THE PE STAMP IN THIS PLAN SET COVERS ONLY THE MODIFICATIONS SHOWN CLOUDED IN RED AND SIGNIFIED BY 1C, WHICH MODIFY THE ORIGINAL BRIDGE PLANS TO UTILIZE A TRADITIONAL FULL-DEPTH, CAST-IN-PLACE CONCRETE DECK. THE DECK REINFORCEMENT IS DESIGNED PER CURRENT WISCONSIN DOT BRIDGE MANUAL.

NO.	DATE	REVISION	BY
1C	8/3/18	REMOVE PRECAST PANELS	PMF

STRUCTURE B-30-112

IH 94 WB / USH 41 NB OVER CTH A

GENERAL PLAN & ELEVATION

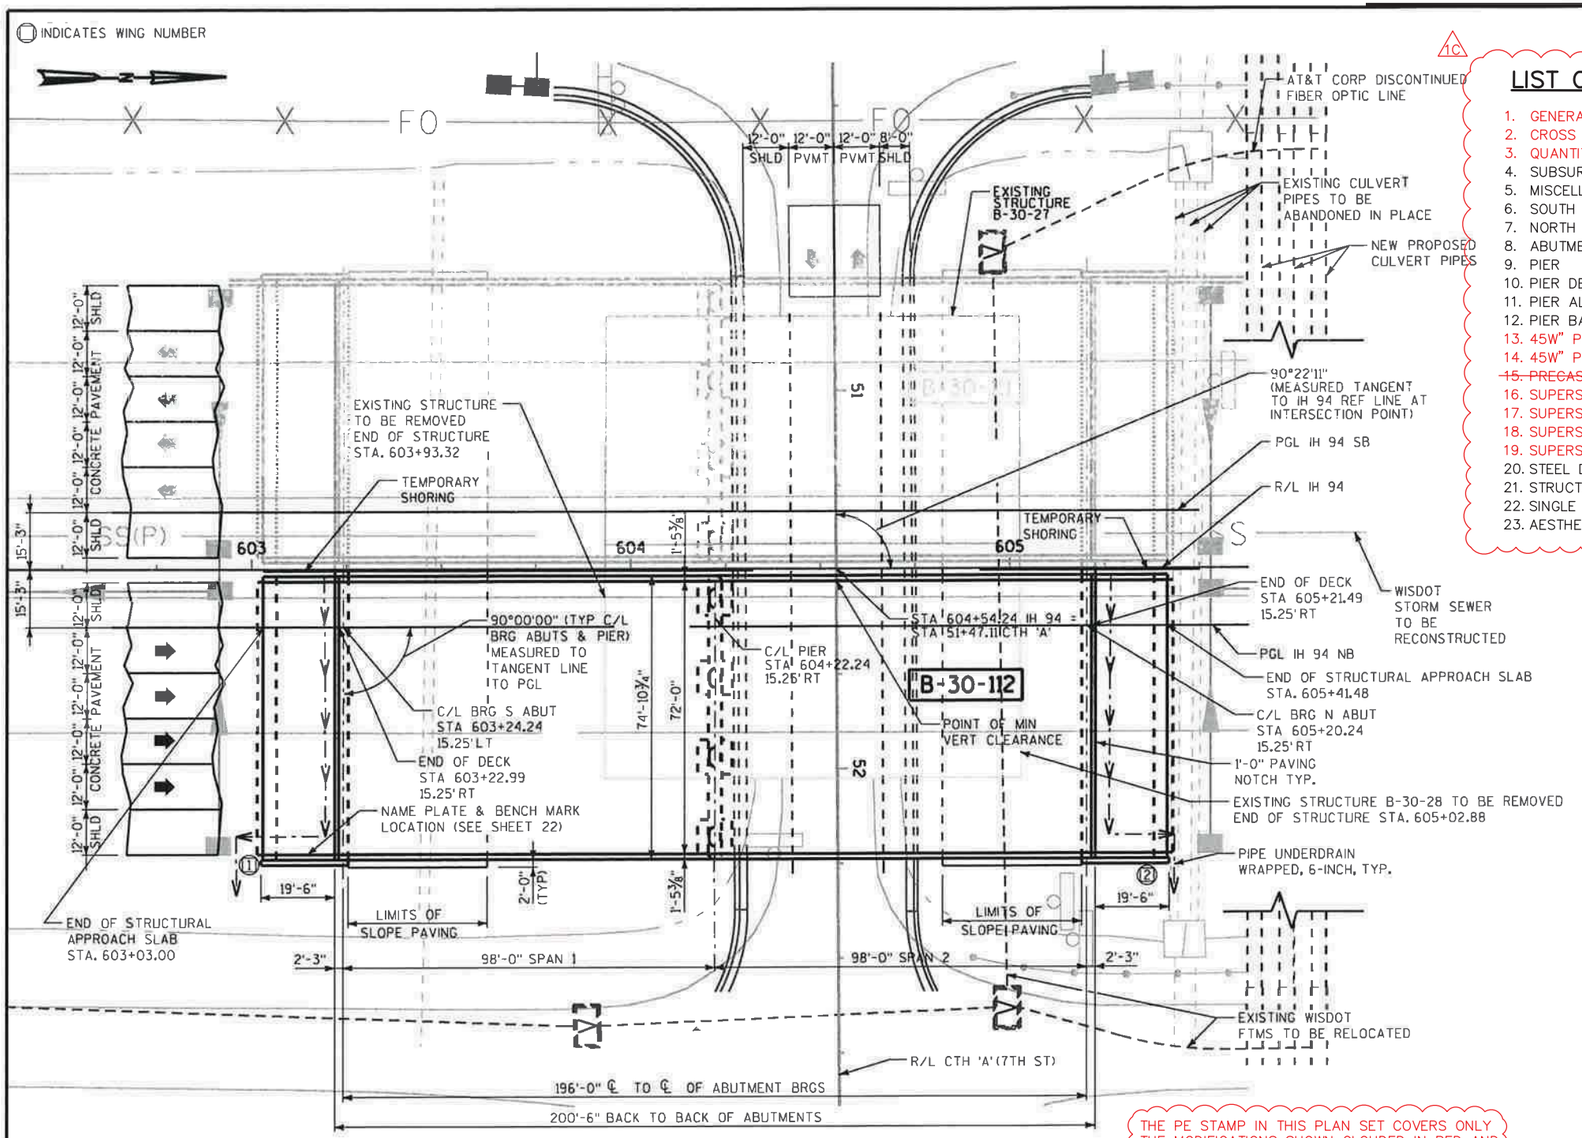
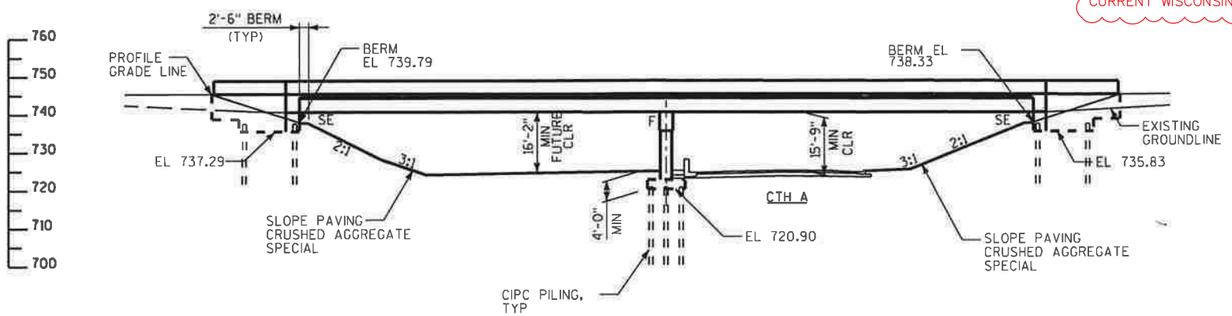
~~PRESTRESSED DECK PANELS,~~
~~CONCRETE MASONRY .....f'c = 6,000 psi~~
~~PRESTRESSING STRANDS = 3/8 INCH DIA. WITH ULTIMATE TENSILE STRENGTH OF 270,000 psi~~

45W" PRESTRESSED GIRDER

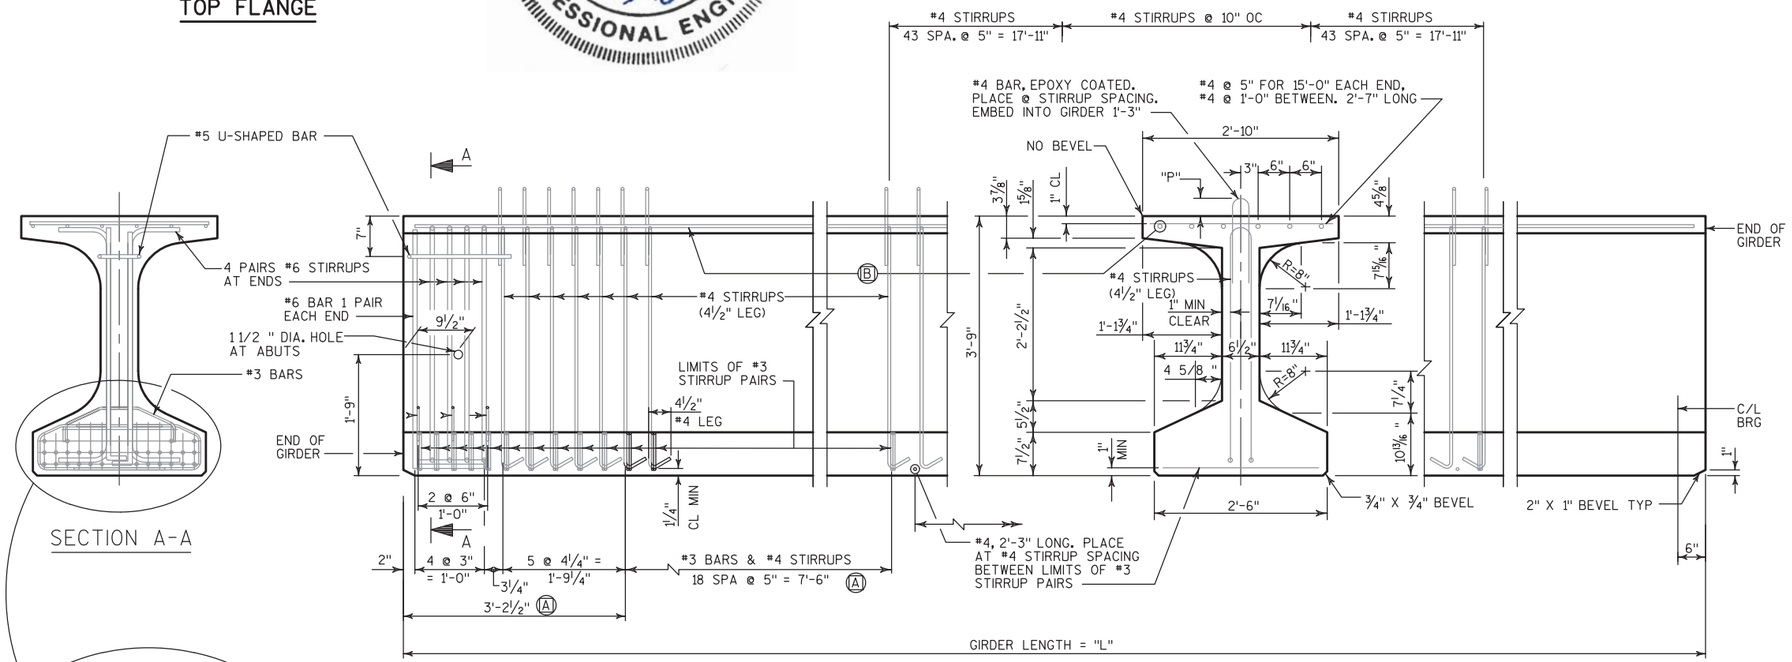
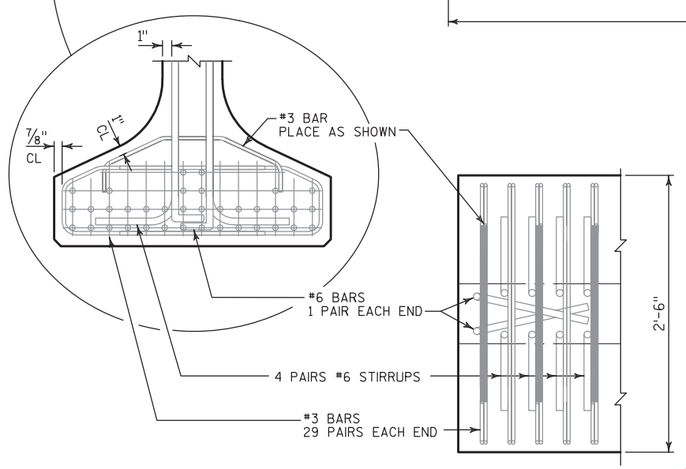
SPAN	GIRDER LENGTH "L"	TOTAL DEAD LOAD DEFL. (IN.) 1/10	2/10	3/10	4/10	5/10	6/10	7/10	8/10	9/10	CONC. STRGTH. f'c (p.s.i.)	"P" 1ST ⅓ OF GIRDER	"P" MID ⅓ OF GIRDER	"P" END ⅓ OF GIRDER	DIA. OF STRAND (IN.)	DRAPED PATTERN TOTAL NO. OF STRANDS	f'ci (P.S.I.) ✳	(IN.) "A"	"B" MIN.	"B" MAX.	"C"	UNDRAPED PATTERN TOTAL NO. OF STRANDS	f'ci (P.S.I.) ✳
~~1&2~~	~~98'-4½"~~	~~½~~	~~1~~	~~1½~~	~~1¾~~	~~1⅞~~	~~1¾~~	~~1½~~	~~1~~	~~½~~	~~8000~~	~~7¾"~~	~~7⅝"~~	~~7¾"~~	~~0.6~~	~~36~~	~~6400~~	~~40~~	~~14~~	~~17~~	~~5~~	~~N/A~~	~~N/A~~
		△ DECK PANEL DEAD LOAD DEFL. (IN.)																					
~~1&2~~	~~98'-4½"~~	~~¼~~	~~½~~	~~¾~~	~~15/16~~	~~7/8~~	~~15/16~~	~~¾~~	~~½~~	~~¼~~

△ DEFLECTIONS SHOWN INCLUDE 2½" HAUNCH GROUT OVER ~~GIRDER~~ TOP FLANGE

SLAB HAUNCH DETAIL

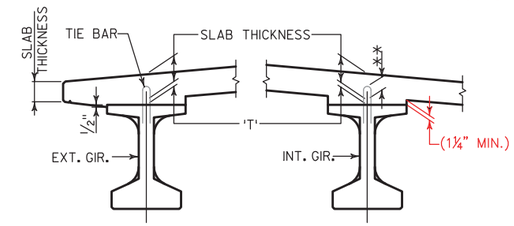
1C

IF 1¼" MINIMUM HAUNCH HEIGHT AT EDGE OF GIRDER CANNOT BE MAINTAINED, THE GRADE LINE MAY BE REVISED BY THE ENGINEER AT THE OPTION OF THE CONTRACTOR. THE PLAN SLAB THICKNESS SHALL BE HELD. NOTIFY THE STRUCTURES SECTION IF THE GRADE LINE IS RAISED FROM THE PLAN PROFILE BY MORE THAN ½" OR,

** IF 3" MINIMUM DECK EMBEDMENT OF TIE BAR CANNOT BE OBTAINED.

NOTE: AN AVERAGE HAUNCH ('T') OF 2.5" WAS USED IN THE QUANTITY "HPC MASONRY STRUCTURES".

PRECAST DECK PANEL LAYOUT

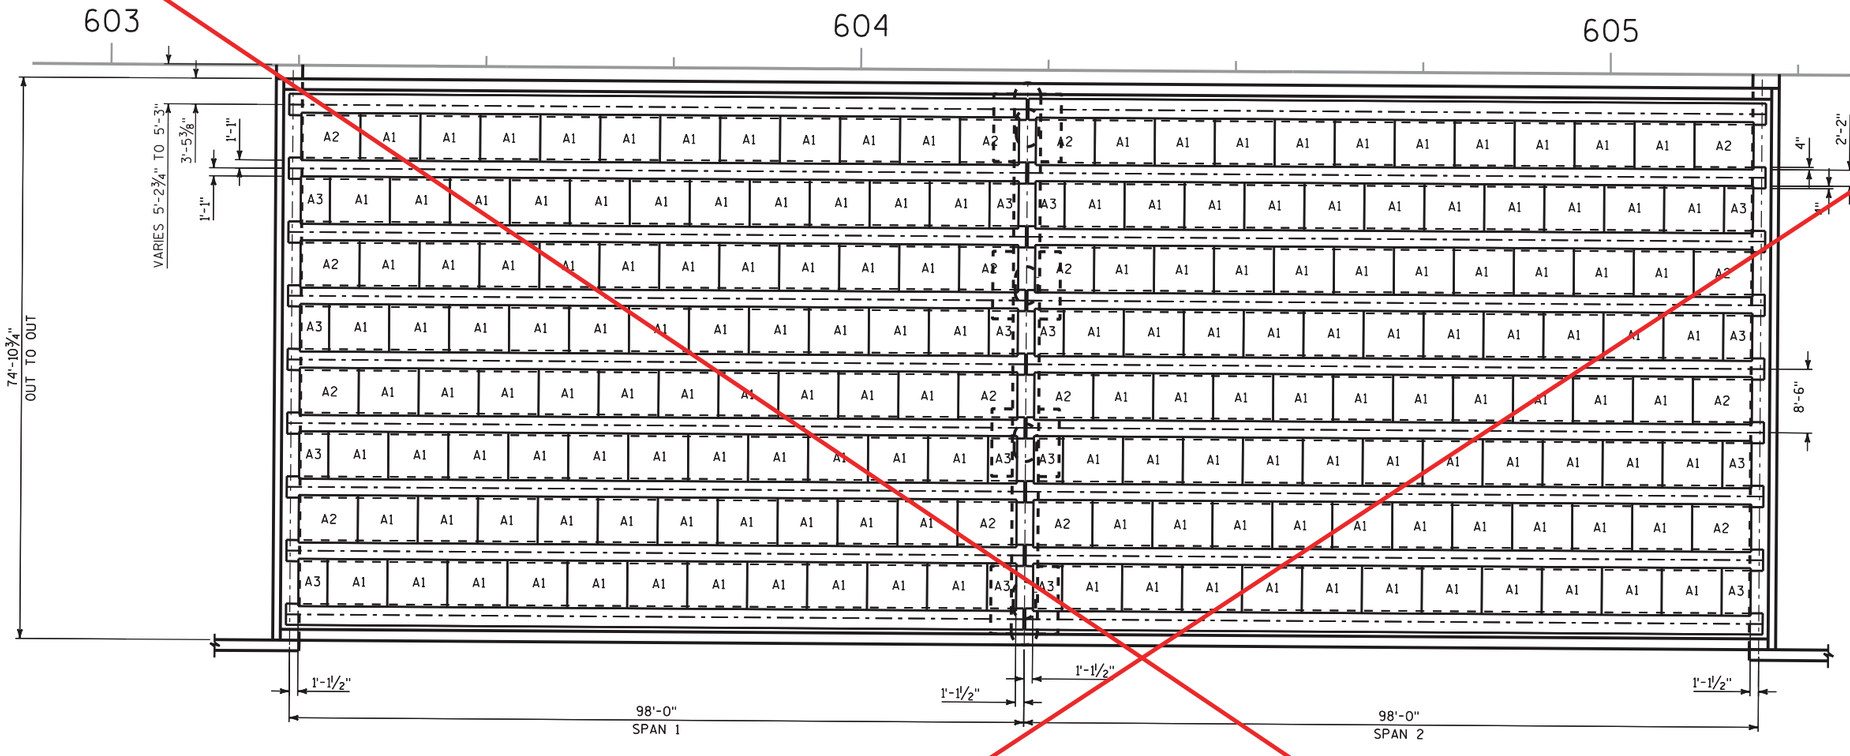
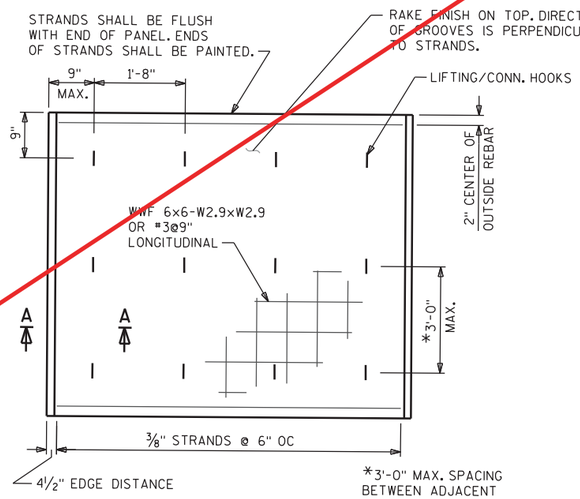
THE PE STAMP IN THIS PLAN SET COVERS ONLY THE MODIFICATIONS SHOWN CLOUDED IN RED AND SIGNIFIED BY 1C, WHICH MODIFY THE ORIGINAL BRIDGE PLANS TO UTILIZE A TRADITIONAL FULL-DEPTH, CAST-IN-PLACE CONCRETE DECK. THE DECK REINFORCEMENT IS DESIGNED PER CURRENT WISCONSIN DOT BRIDGE MANUAL.

NO.	DATE	REVISION	BY
AC	8/3/18	REMOVE PRECAST PANELS	PMF

SUPERSTRUCTURE PLAN

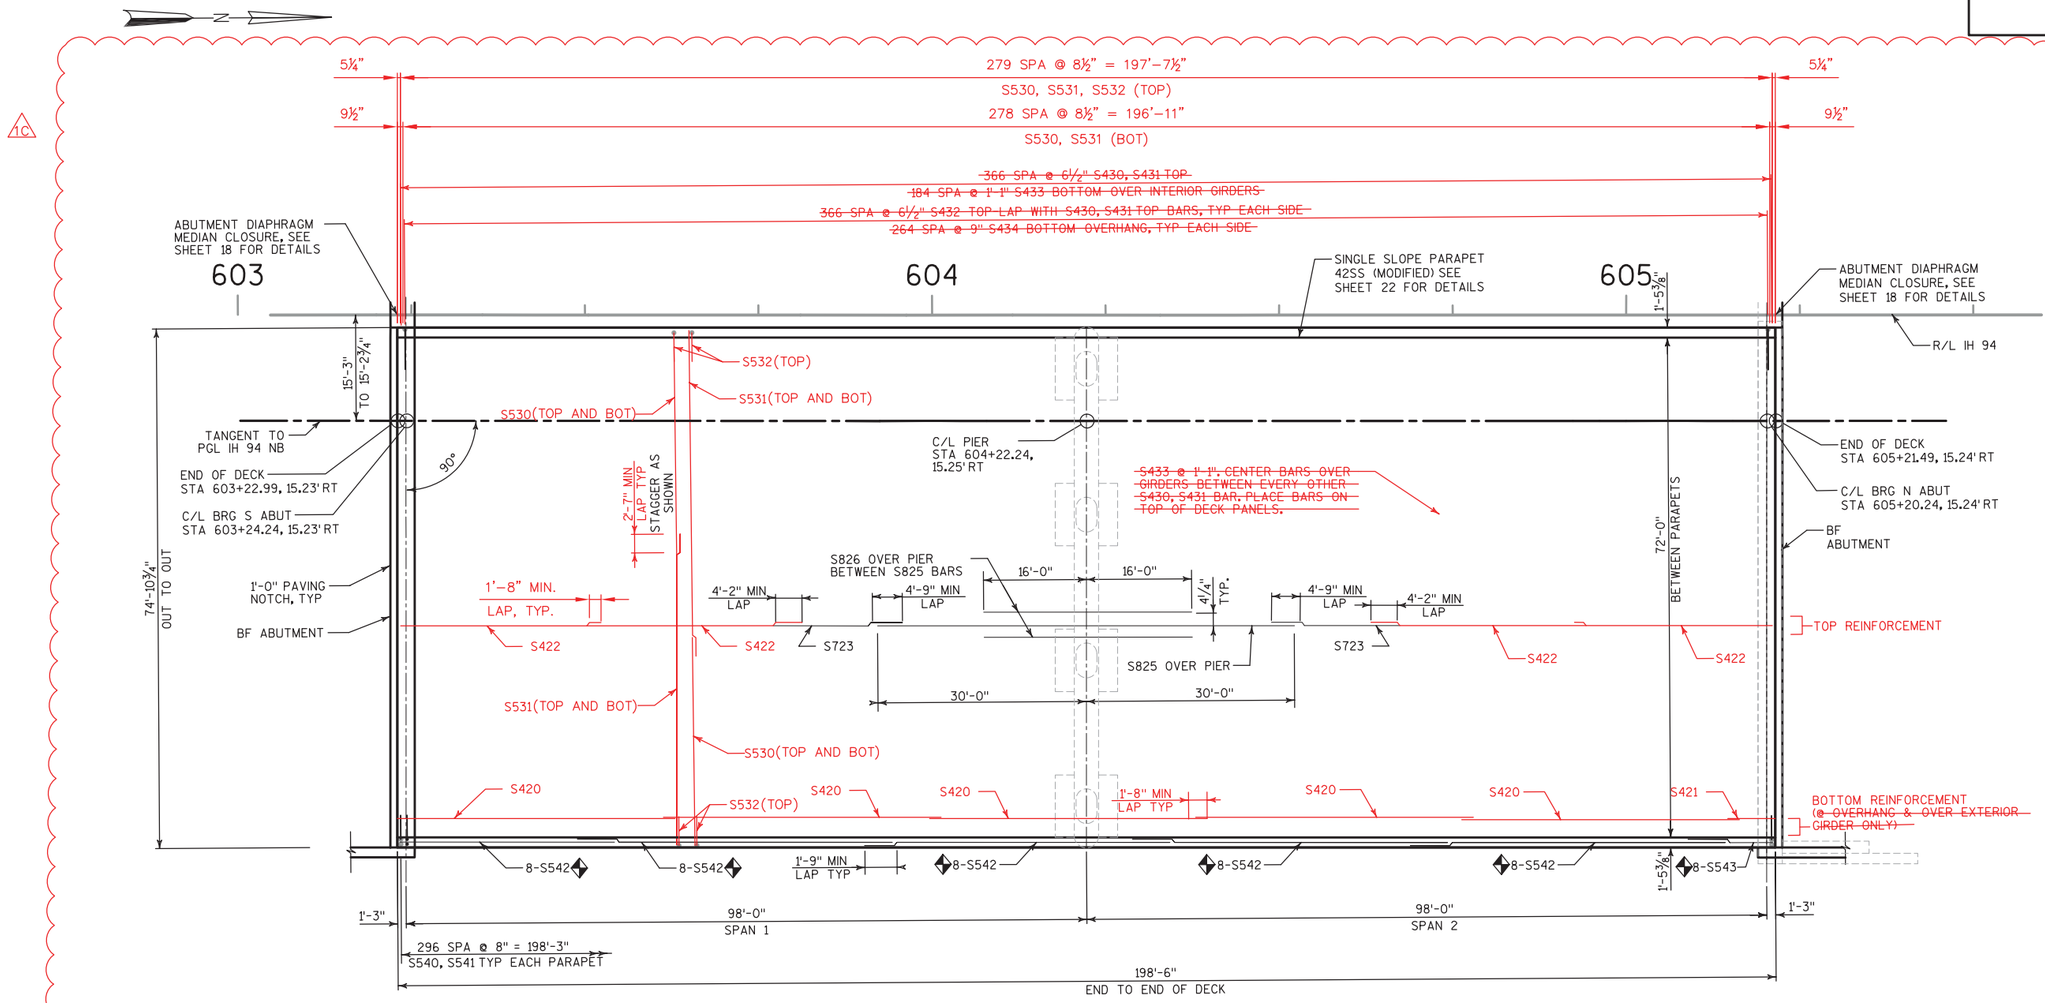
THE PE STAMP IN THIS PLAN SET COVERS ONLY THE MODIFICATIONS SHOWN CLOUDED IN RED AND SIGNIFIED BY 1C, WHICH MODIFY THE ORIGINAL BRIDGE PLANS TO UTILIZE A TRADITIONAL FULL–DEPTH, CAST–IN–PLACE CONCRETE DECK. THE DECK REINFORCEMENT IS DESIGNED PER CURRENT WISCONSIN DOT BRIDGE MANUAL.

SUPERSTRUCTURE CROSS SECTION

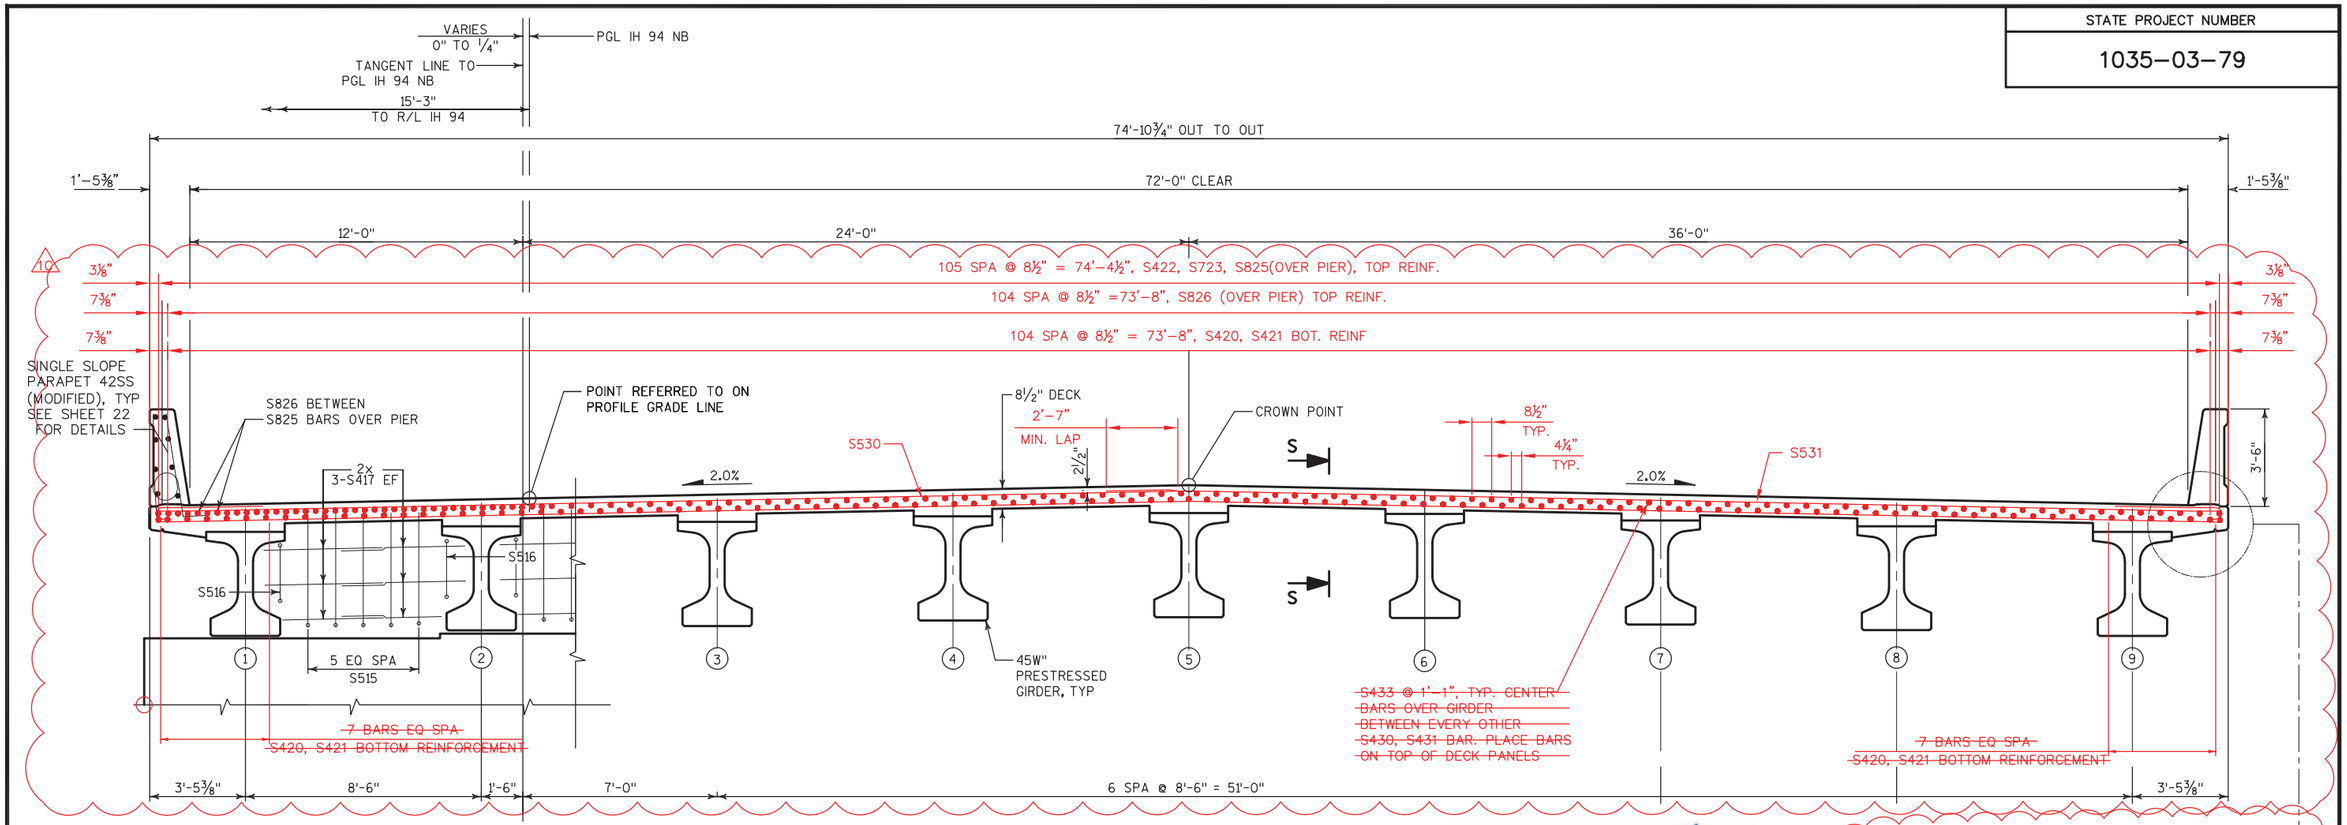
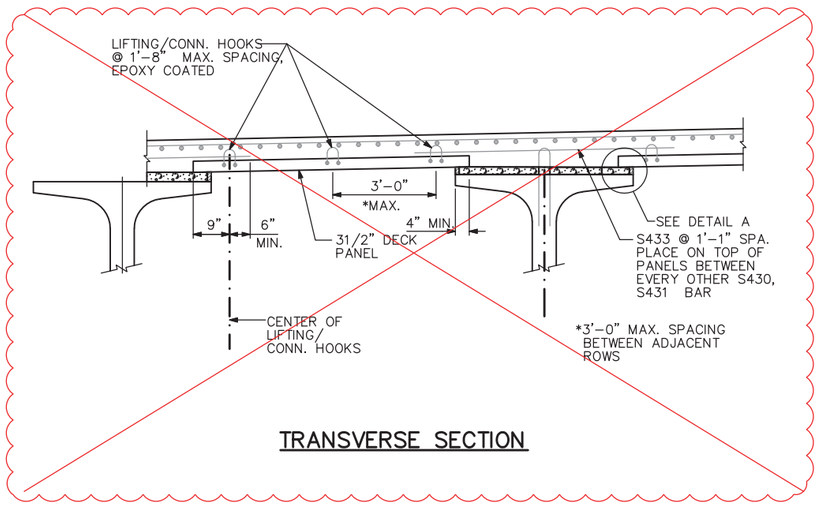
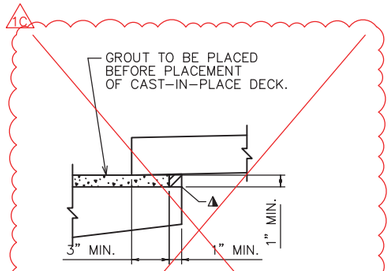
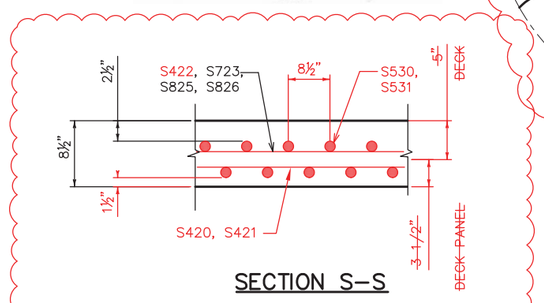
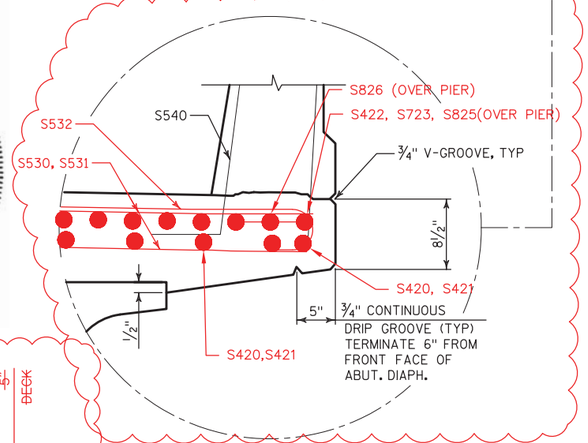
1C

1C

1 HIGH-DENSITY EXPANDED POLYSTYRENE ADHERED TO TOP OF GIRDER FLUSH WITH EDGE OF FLANGE.

1C

1C
